THE NATIONAL GRID COMPANY plc

GRID CODE REVIEW PANEL

**GRID CODE CHANGES TO INCORPORATE NEW GENERATION
TECHNOLOGIES AND DC INTERCONNECTORS (GENERIC PROVISIONS)**

APPENDIX 2: CHANGES TO THE GRID CODE PROPOSALS

Figure 2.1

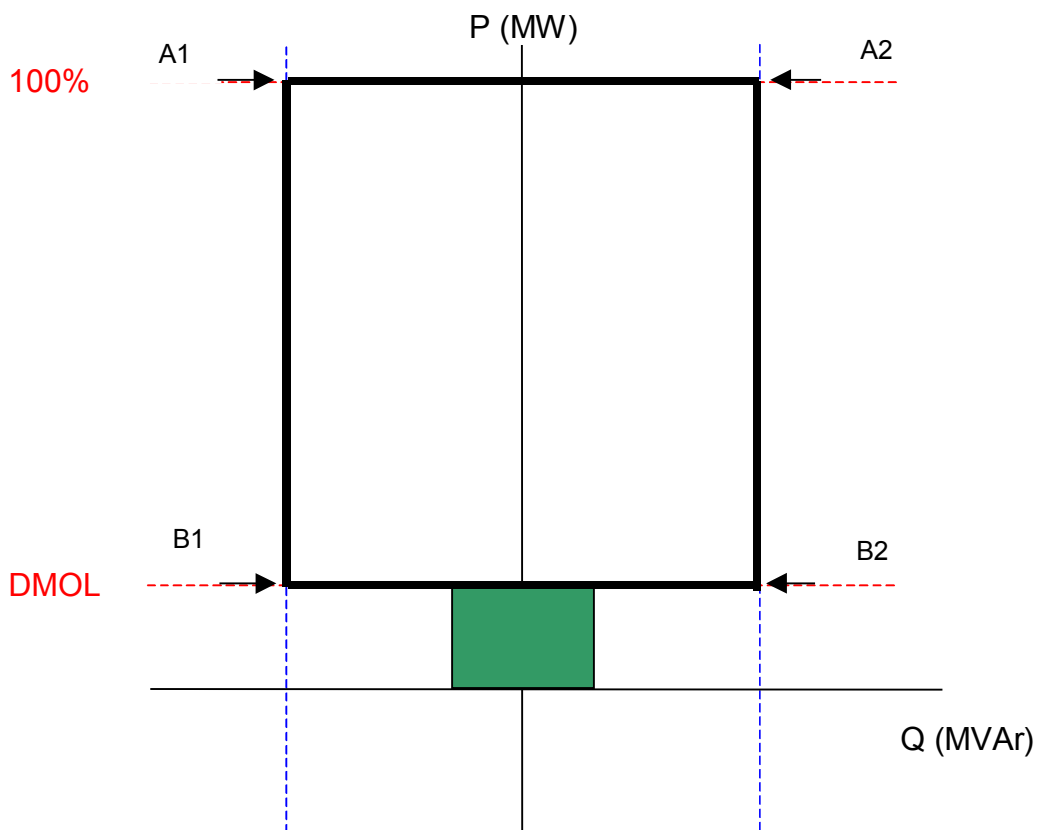
The diagram shown in Figure 2.1 below has been introduced from a proposal made by the BWEA at the last forum (BWEA's diagram was based on the Irish Grid Code proposal). There is no change in this requirement from that proposed in the first consultation, however the inclusion of such a diagram is considered to aid clarity. Within area A1A2B2B1, the plant is subject to MVAR dispatch instructions by the Grid operator. In the green area, with the plant being required to remain reactive power neutral, a tolerance of $\pm 5\%$ of rated MW output around zero MVAR is permitted. In addition, operation in this area is at the discretion of the owner whilst ensuring smooth transition between the two areas.

Point A1 is equivalent to: 0.95 leading power factor at rated MW output
Point A2 is equivalent to: 0.95 lagging power factor at rated MW output

Figure 2.2

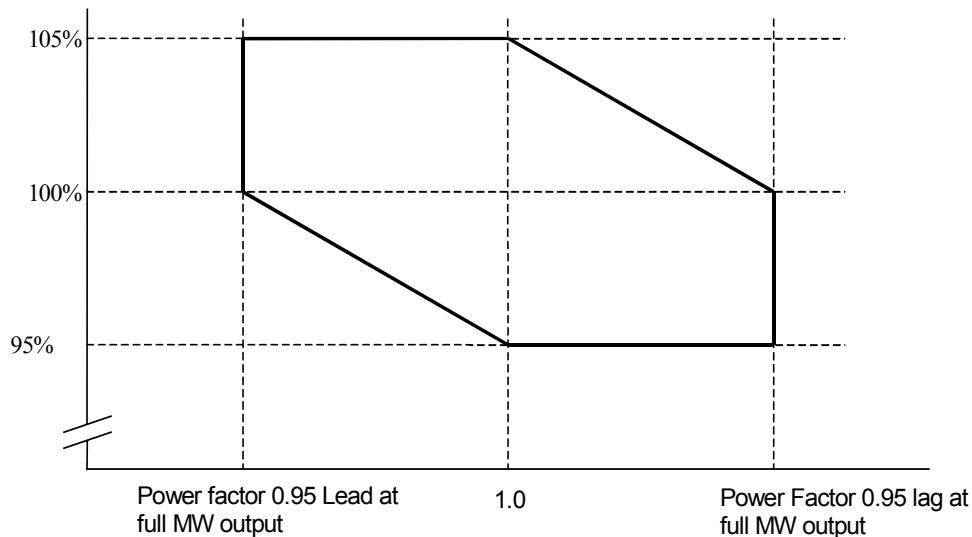
For embedded generation plant connected at 33kV or below, the power factor range, which applies within $\pm 5\%$ of nominal system voltage, is modified to adopt the proposal made by the BWEA as shown in Figure 2.2 below. This is a reduction in the requirements for generating MVARs at high system voltages and absorbing MVARs at low system voltages. This allows for the lack of transformers with on-load tap-changers that help in the control of the voltage profile within the wind farm.

Figure 2.3 (a)

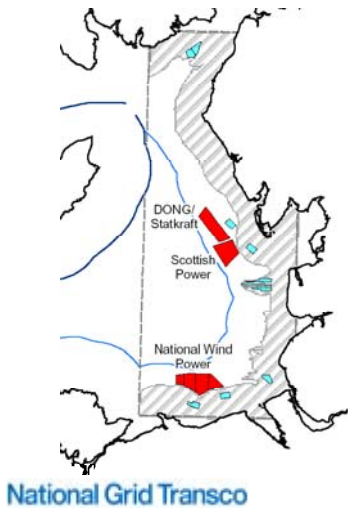
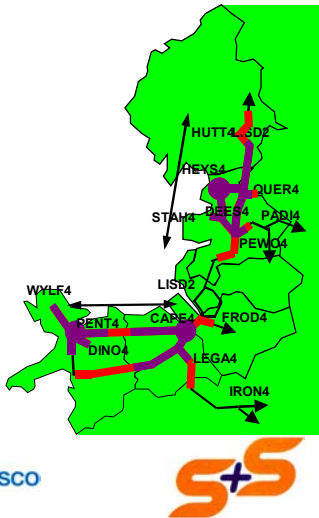
The 15% retained voltage proposal is unacceptable. NGC studies have demonstrated that with a retained voltage of 15%, large areas of the transmission system would become sterilised allowing only a limited amount of wind farms to connect and preventing further connection of generation in those areas, either renewable or conventional. Figure 2.3 (a, b and c) shows the effect of a fault disconnecting existing generation plant and associated voltage dip propagation illustrating the zone of influence for a 15% and 7.5% retained voltage. Whilst the geographical areas reduce in the case of 7.5% voltage, the same issue remains in terms of wind farm connection restrictions. These restrictions would have a severe impact on the Governments' targets of 10% of electricity requirements by the year 2010 and subsequently 15% by the year 2015.

North Wales Coast:
 121 km at <7.5% (purple)
 243 km at <15% (red)
 +
 North Western Coast:
 67 km at < 7.5% - purple
 134 km at < 15% (red)
 becomes sterilised

Figure 2.4

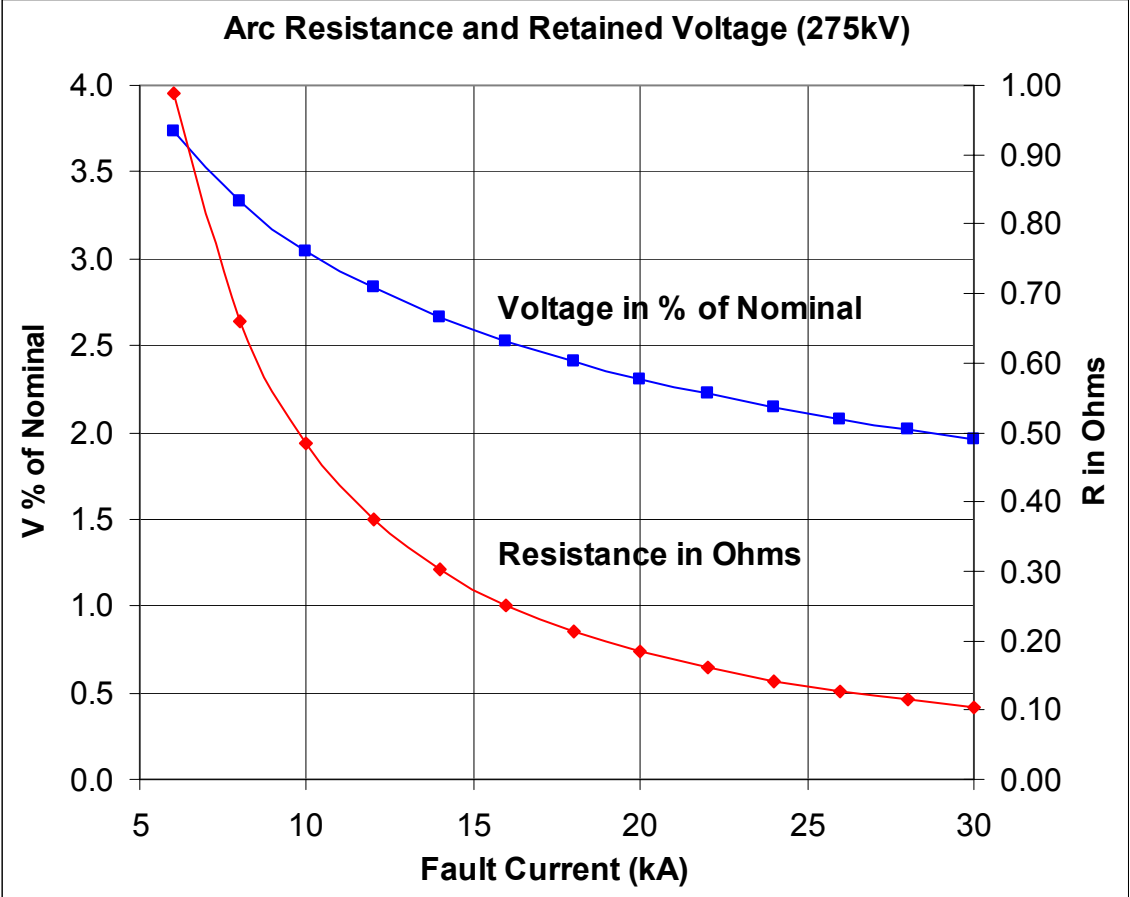
In the event of a circuit flashover, it should be noted that even when the arc resistance is taken into account, the voltage at the point of fault will still be very low and in the range of 1.2% to 3% as shown in Figure 2.4. The arc resistance is calculated using the well-known A C Van Warrington empirical formula found in many power system protection textbooks.

**Figure 2.5
Compliance Process**

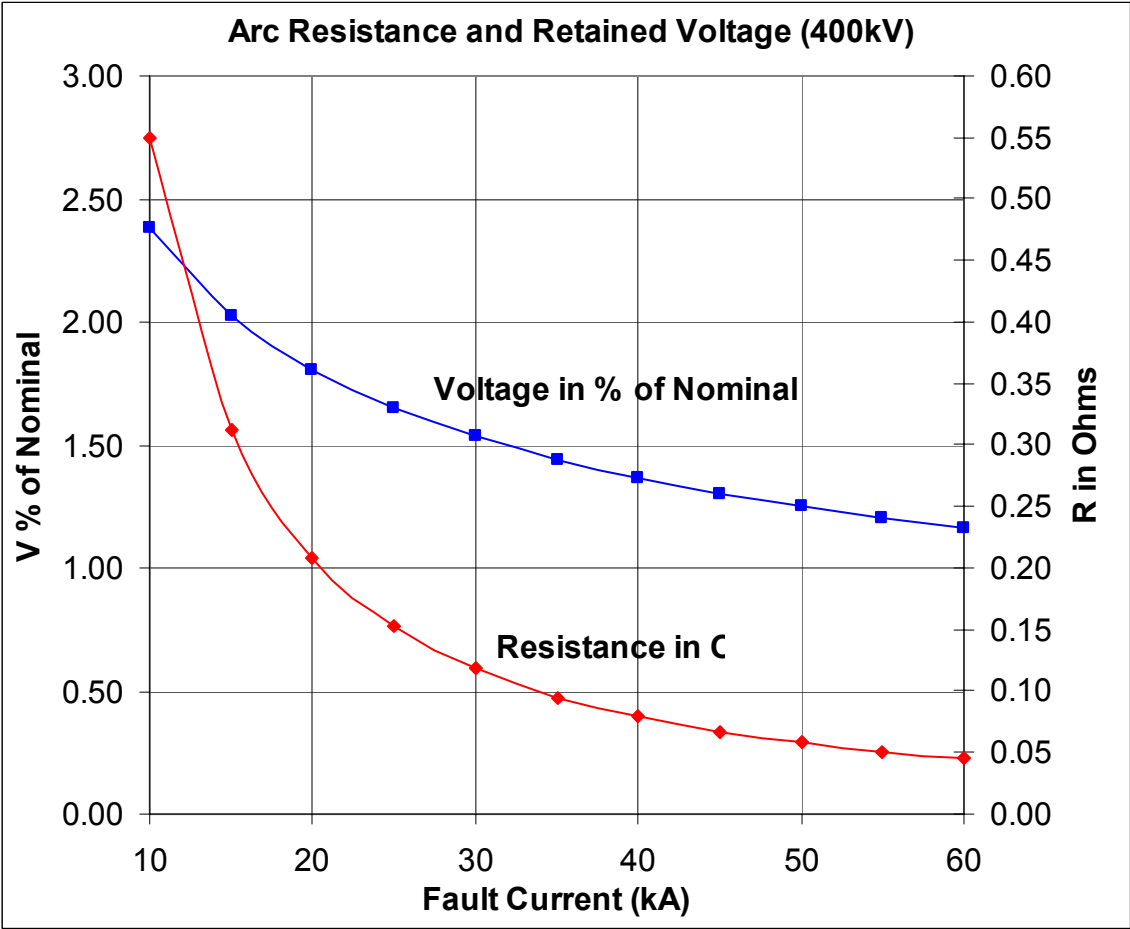
disputes. An illustration of the generic and project-specific compliance process is shown in Figure 2.5.

Figure 2.7

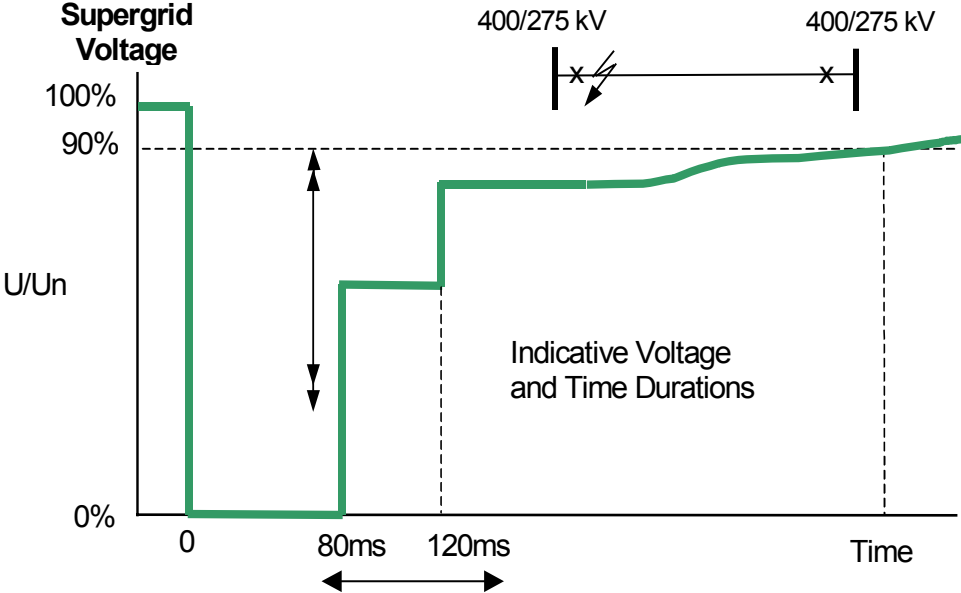
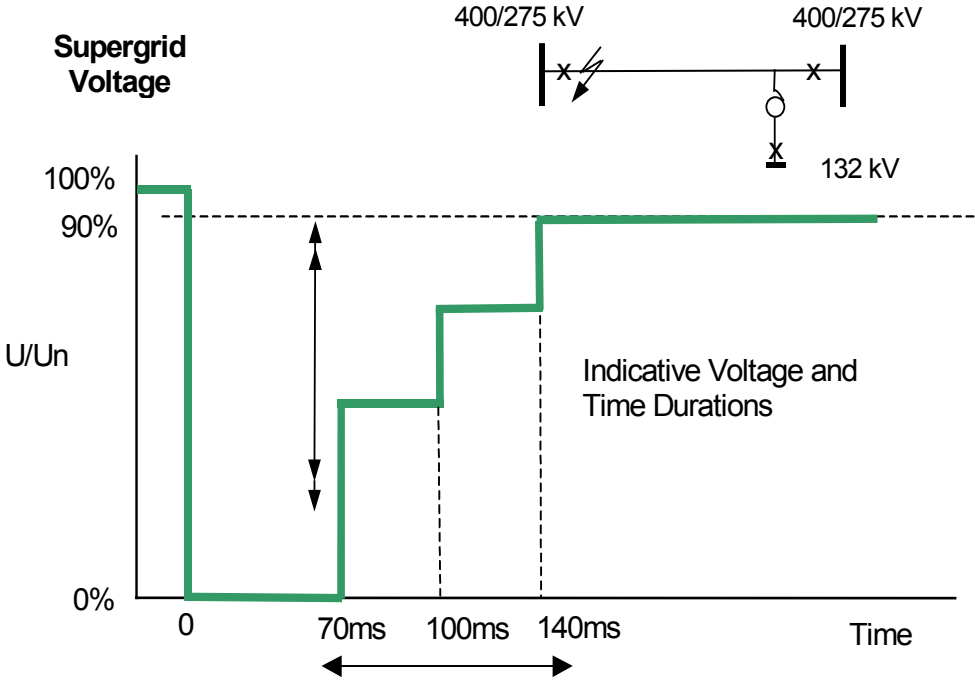
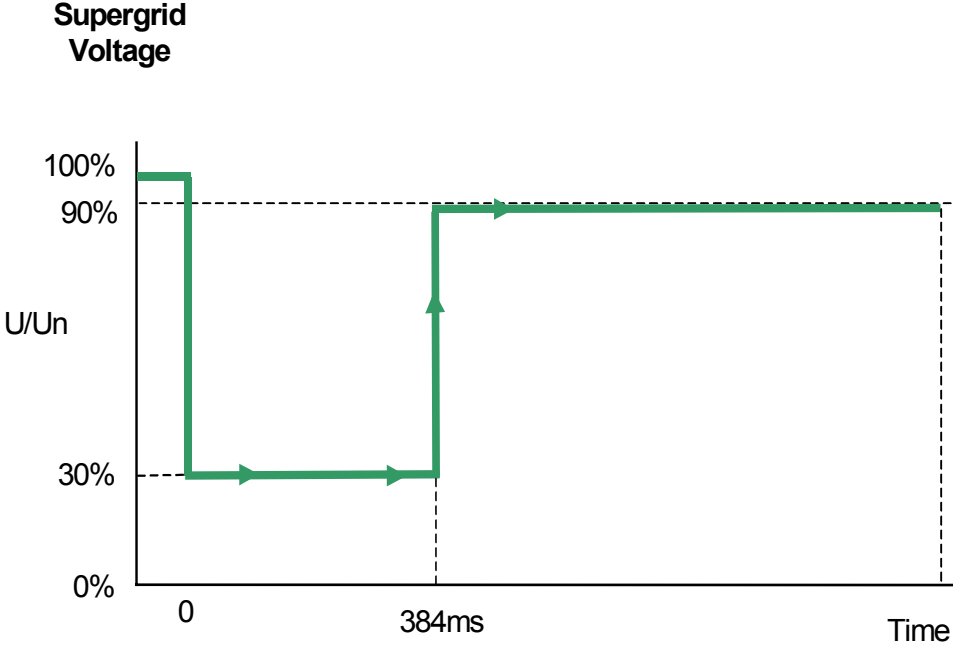
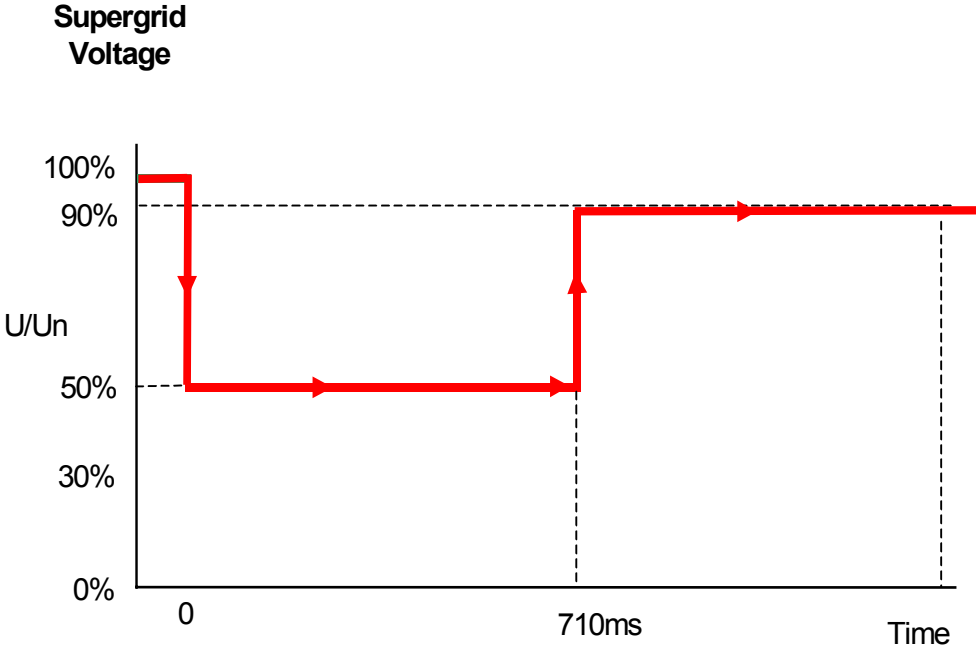
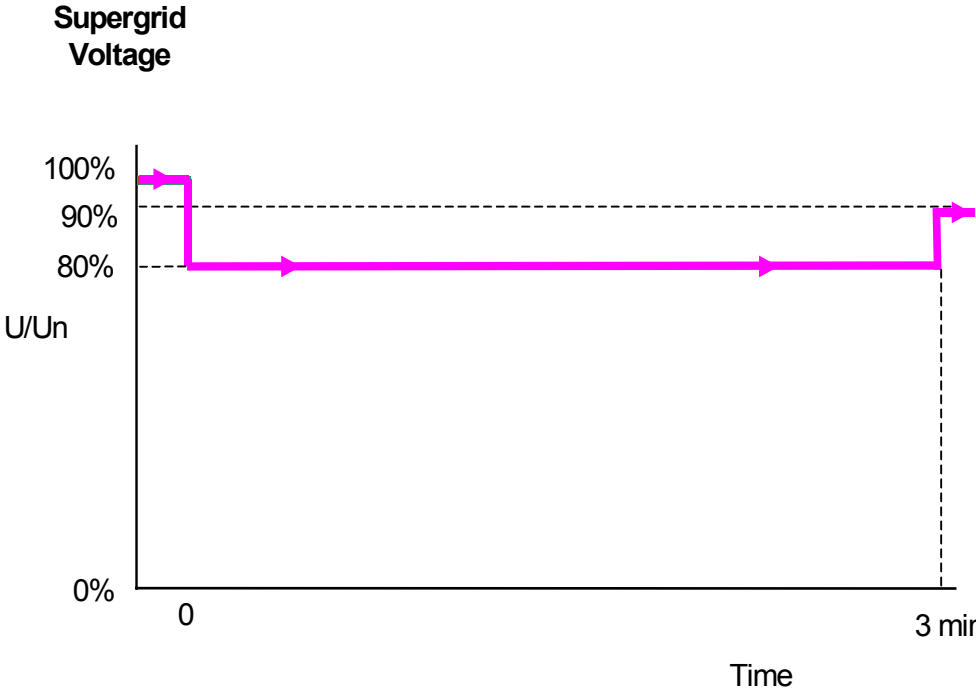
A voltage – duration profile is introduced as shown in Figure 2.6 to explicitly specify the expected performance requirement for voltage dips durations greater than 140ms. This performance is expected to be inherent in the existing conventional generation plant connected to the transmission system. The voltage - duration profile is not a voltage-time response curve that would be obtained by plotting the transient voltage response of a busbar or a machine terminal voltage to a given network disturbance. Rather, each point on the profile represents a voltage level and an associated time duration which connected plant must withstand or ride through. Figure 2.7 (a to e) illustrates the meaning of the voltage-duration profile for durations up to 140ms (a and b) and greater than 140ms (c, d and e) i.e. in the shaded area of Figure 2.5.
